PROFESSIONAL SERIES (PRO Z -S)

Date: March 09, 2023

Part Numbers Affected: 680-00536 Front Yoke Assembly
680-00536-4021 Front Yoke Assembly

Subject: 30mm Front Yoke Replacement Service Kit

FIGURE 1

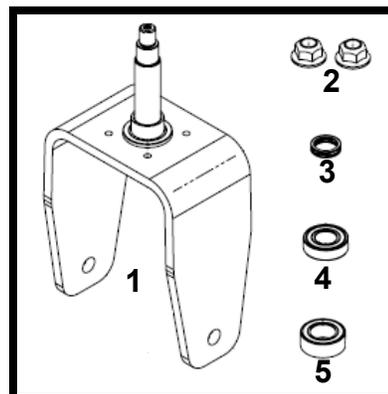
We have made an improvement for the Front Yoke Assembly used on the above listed Affected Models Manufactured from November 01, 2017 through October 19, 2022. This improved Front Yoke Assembly consist of a larger spindle shaft of 30mm from the previous 25mm spindle shaft.

1. Order quantity two (2) of Service Kit **759-05919** from your normal parts source. **NOTE: The Service Kit 759-05919 contains the parts needed for the replacement of only one Front Yoke Assembly.**
